Date: May 15, 2007

From: Robert H. Gilkeson, Registered Geologist, RCRA Groundwater Specialist

Subject: Comment on the New Mexico Environment Department Notice of Disapproval issued to Sandia National Laboratories Albuquerque Facility on November 20, 2006 concerning the Corrective Measures Implementation Work Plan for the Mixed Waste Landfill.

Figure 1. Map Showing the Six Locations Proposed by Sandia for the Collection of Soil Gas Samples. The proposed locations are circled in red.

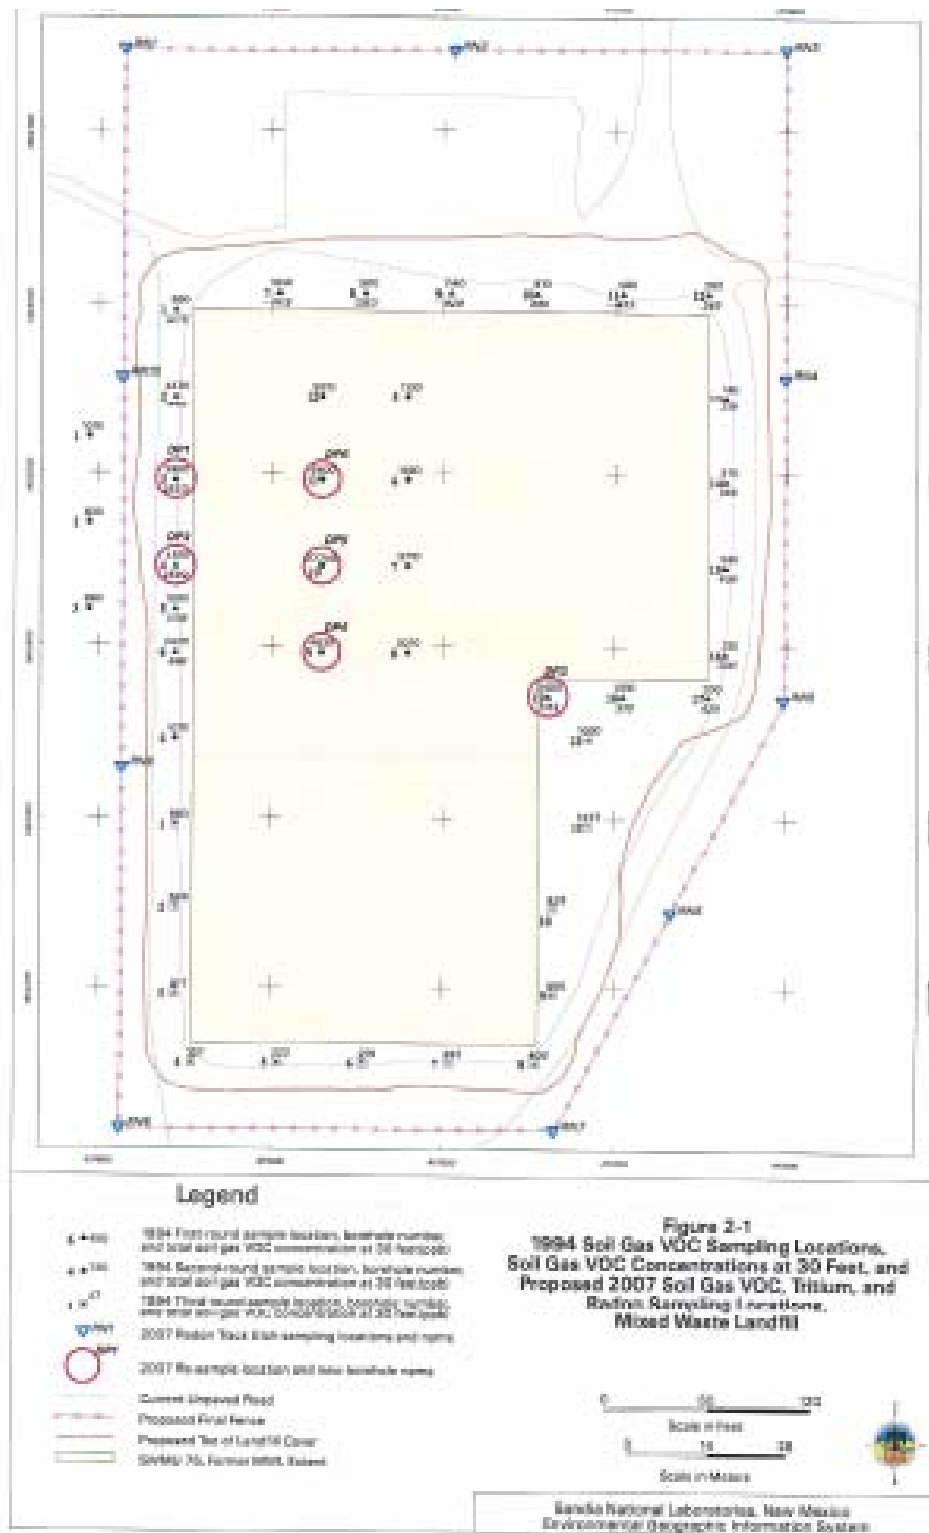
The proposal by Sandia/DOE to take new soil gas measurements at only six locations at the MWL is nonresponsive to the NMED concern that rupturing of containers and the leaking of their contents could have occurred. The rupturing of containers could have occurred in any of the disposal pits and trenches and is more likely to have occurred because of the compaction activities with heavy equipment in the past year that were part of installing the subgrade across the entire surface of the 2.6-acre MWL. The fact that NMED approved the installation of the subgrade in the face of issuing a NOD for the CMIP is another example of the poor performance of NMED. The Sandia/DOE proposal is also nonresponsive to the NOD because none of the six proposed locations for new soil gas measurements are located above or below the disposal pits and trenches.

Active Soil Gas Survey. The six locations proposed by Sandia/DOE for measurement of soil gas are circled in red on Figure 1. The proposed locations are where high levels of volatile organic contaminants (VOCs) were measured in the 1994 active soil gas survey that was part of the RCRA Facility Investigation. Figure 1 shows the locations of where soil gas measurements were taken at shallow depths with a Geoprobe^R. The 1994 survey collected soil gas at depths of only 10 ft and 30 ft below ground surface (bgs). The RCRA Phase 2 Report noted that the soil gas concentrations were markedly higher at the 30 ft depth. The measured concentrations at the 10-ft and 30-ft depth are in Table 1 for the six locations proposed by Sandia/DOE for collecting new soil gas samples. The great increase at the 30-ft depth is evidence that the RCRA Facility Investigation in the 1990's failed to provide the necessary knowledge of the nature and extent of contamination released from the MWL to the unsaturated zone. Therefore, the new proposal by Sandia/DOE to only measure soil gas to a depth of 30 ft bgs is unacceptable.

Figure 4. Tritium Contamination Measured in Surface Soils at the Sandia MWL.

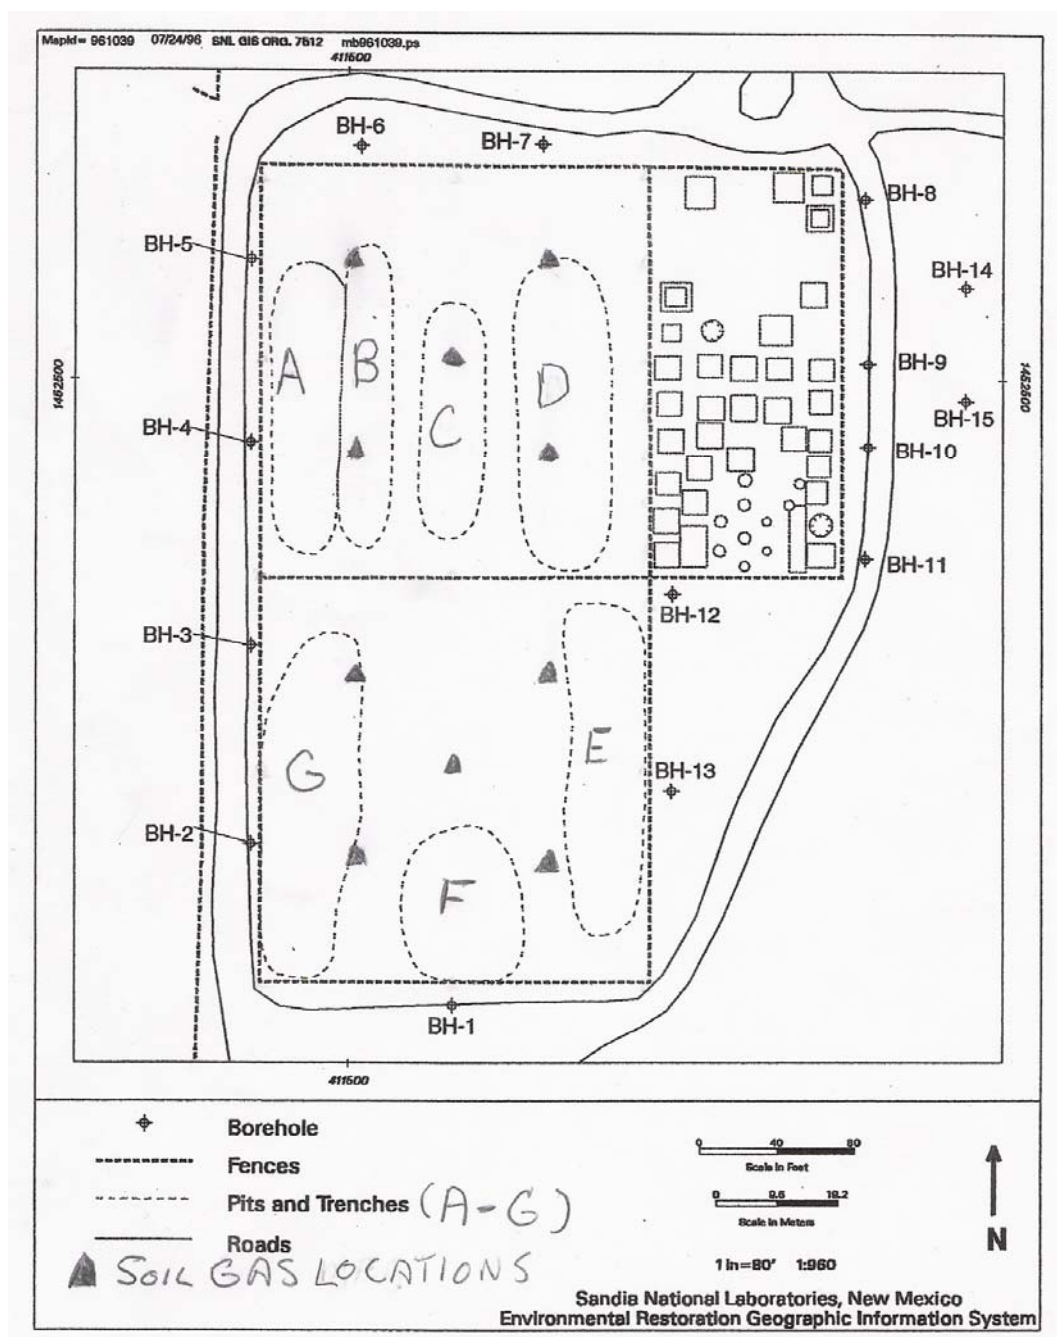
In addition, there are no monitoring wells installed for monitoring groundwater contamination related to the high levels of tritium that are buried in the pits in the classified area and that have released a flux of tritium across the soil surface as shown by Figure 4. It is important to install “inside out” multiple-port wells at a minimum of four locations in the classified area for measuring accurate profiles of tritium and VOC contamination in the unsaturated zone and for investigation of tritium, VOC and other contamination at the water table of the regional zone of saturation. An important location for one of the wells is at Pit 33 where 822 Curies of Tritium was buried. The second “inside out” well is needed north of the classified area to replace existing monitoring well MW1 where high levels of nickel and chrome are measured in groundwater samples. The third “inside out” well should be located in the southeastern corner of the classified section to investigate contamination from the “acid pit” where chemical wastes were disposed of beginning in 1959. The location for the fourth vertical “inside out” well in the classified area should be based on the findings from the new soil gas surveys.

The highest tritium contamination is measured immediately south of the disposal pit #33 where 822 Curies of tritium was buried. A monitoring well was never installed at the MWL to monitor the tritium hot spot.

Figure 5. Map of the Sandia Mixed Waste Landfill showing the locations of the six monitoring wells MW1 to MW6 and the background water quality well BW1.

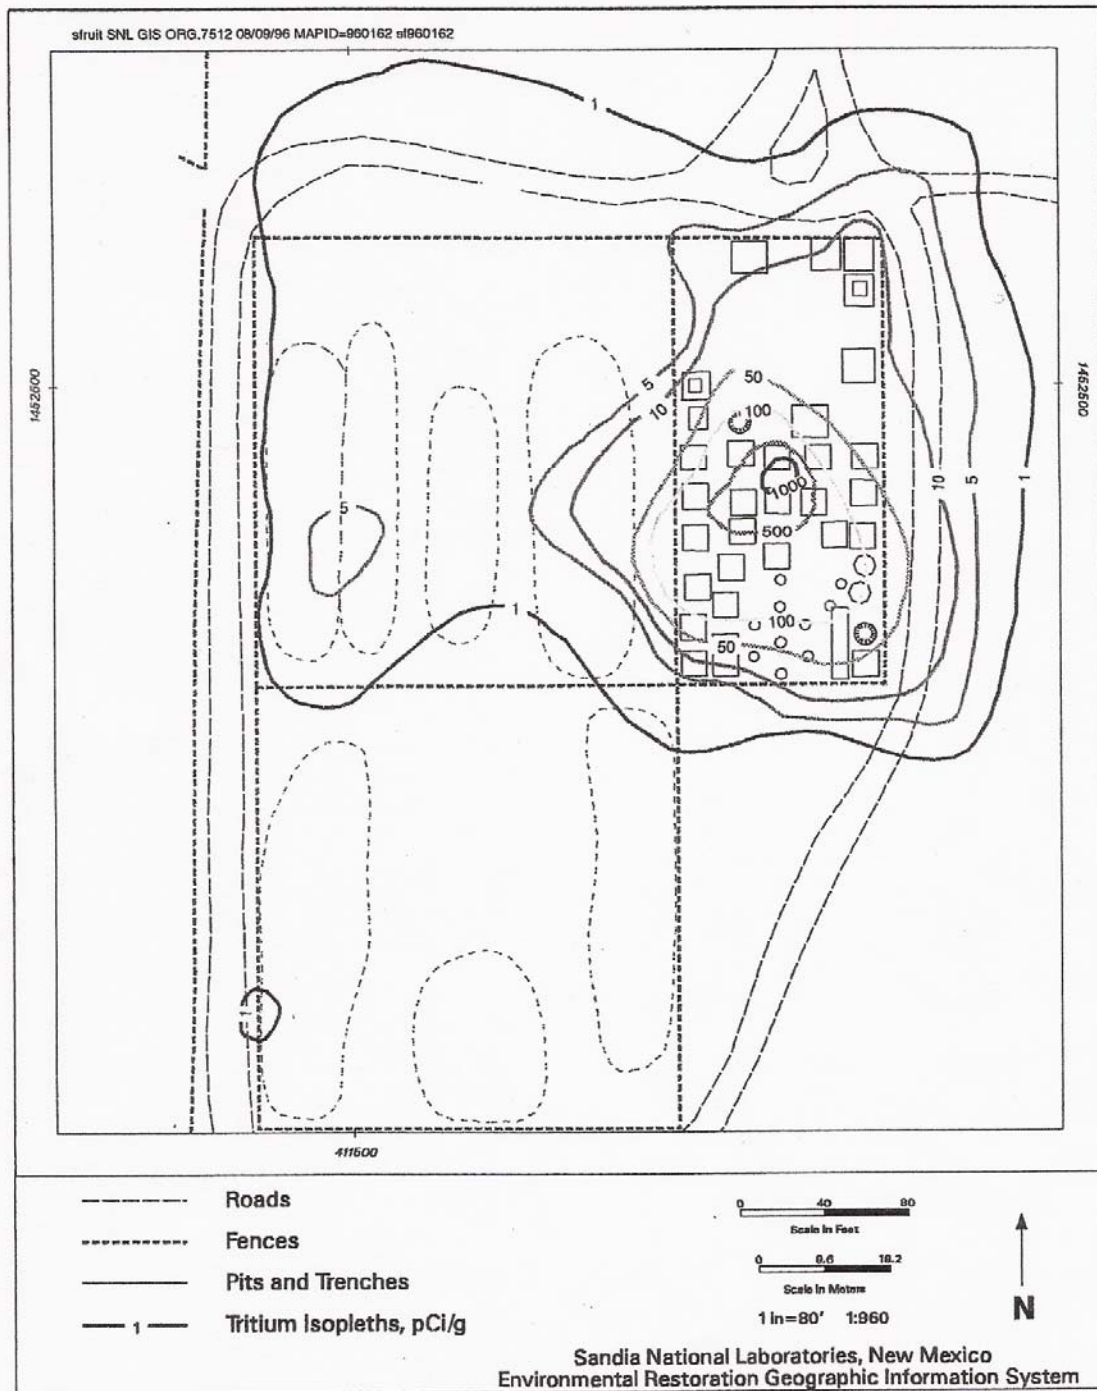
The NMED concern for the corrosion of stainless steel well screens also requires replacement of monitoring wells MW1, MW2, and MW3 because these wells also have stainless steel screens. The levels of nickel and chromium measured in water samples from wells MW1 and MW3 exceed the New Mexico Water Quality Standard. The levels of chromium exceed the EPA MCL for drinking water. The NMED Sandia Consent Order has the following requirements for the design and construction of monitoring wells at the Sandia MWL:

The above statement in the NMED Sandia Consent Order also requires replacement of wells MW1, MW2, MW3, MW4 and MW5 at the Sandia MWL. The reasons to replace wells MW1, MW2, and MW3 are described earlier in this presentation.

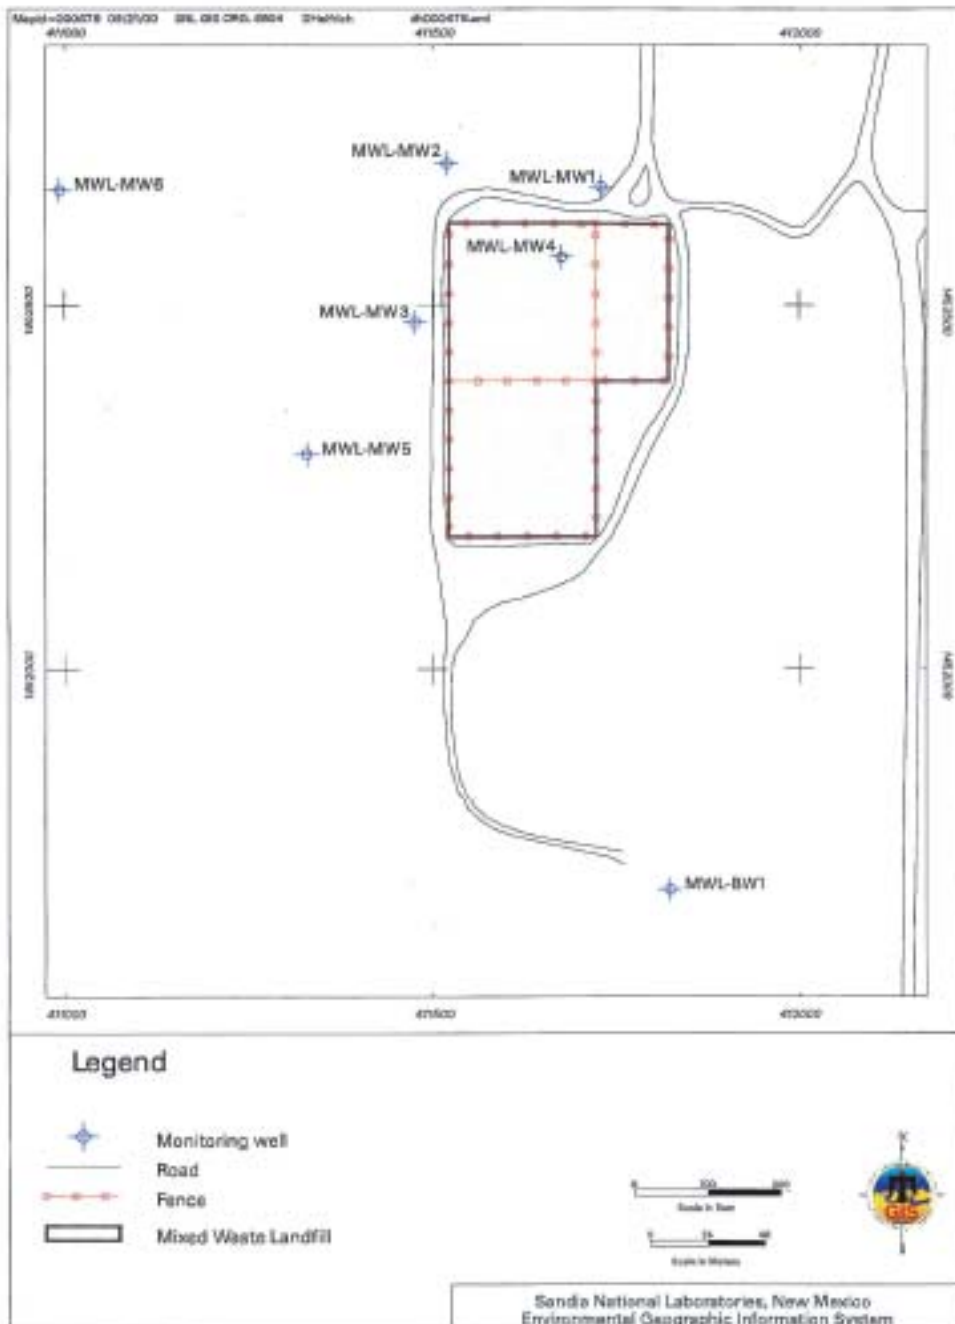
Monitoring well MW4 was installed to investigate contamination at the water table below Trench D. However, Figure 6 shows that the upper screen in well MW4 was installed too deep below the water table for the intended purpose, and therefore, the NMED Consent Order requires that well MW4 be replaced with a new monitoring well. This new multiple-port monitoring well for collection of soil gas samples with a screen installed at the water table should be drilled at an appropriate angle and located along the southwestern side of Trench D in the corridor between Trench D and Trench C.

Well MW5. The intended purpose for well MW5 was to measure water levels and water quality down-gradient of the MWL to improve knowledge of the direction of groundwater travel. However, Figure 6 shows that the well screen is installed across both the alluvial fan sediments and the deeper productive aquifer strata. The NMED Consent Order requires wells to be installed in only one zone of saturation in terms of aquifer properties as follows:

The information on Figure 6 shows that the screen in well MW5 and the lower screen in well MW4 are connecting intervals of different head and hydraulic conductivity.

Figure 7. Water Level Map Showing the Southwest Direction of Groundwater Travel at the Water Table in the Alluvial Fan Sediments (the AF Facies) Below the Sandia Mixed Waste Landfill.

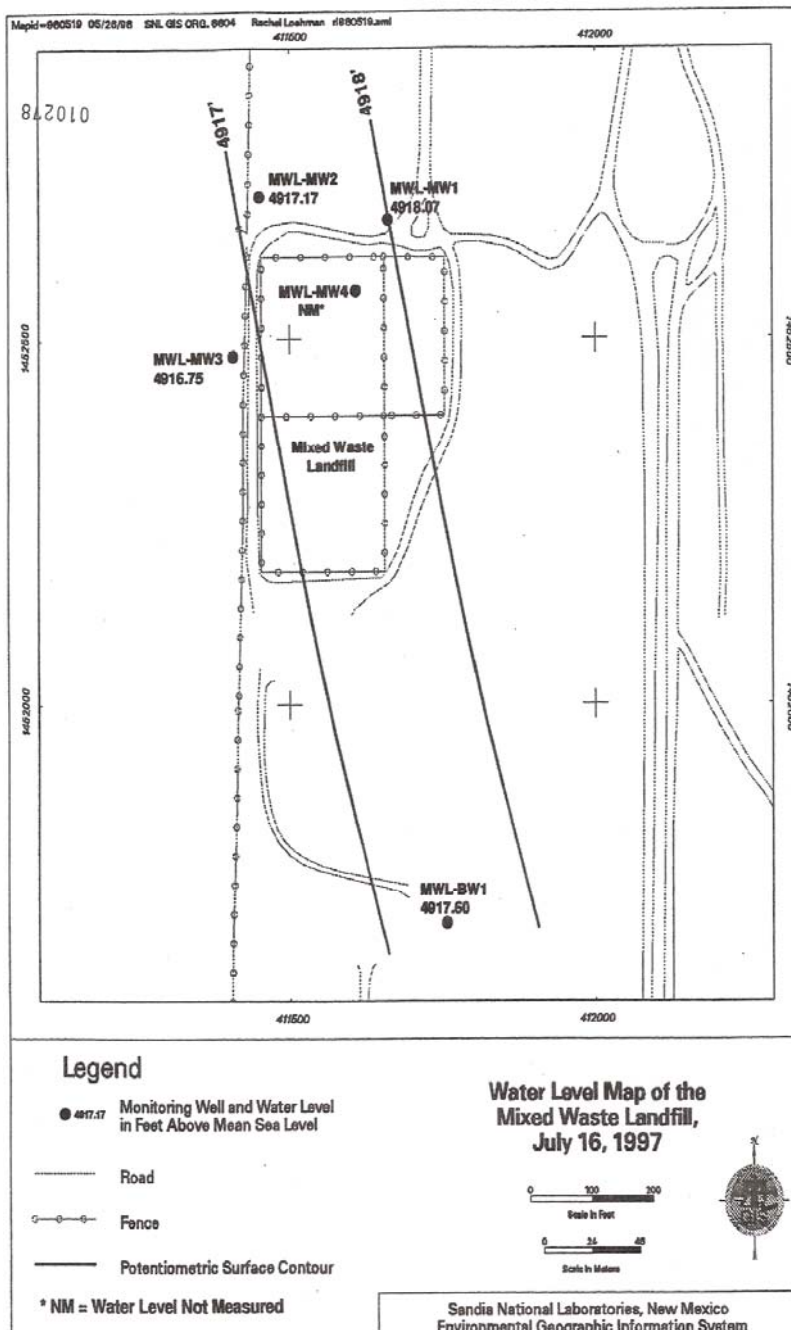
In addition, wells MW1 and MW2 require replacement because they are located north of the MWL and cross-gradient of the southwest direction of groundwater travel at the water table of the regional zone of saturation. See Figure 7.

- Wells BW1, MW1, and MW2 are *cross-gradient* to the direction of groundwater flow in the AF Facies beneath the MWL.
- Well MW3 is the only well in the AF Facies that is located downgradient of the MWL.
RCRA requires a minimum of three wells at downgradient locations near the MWL.
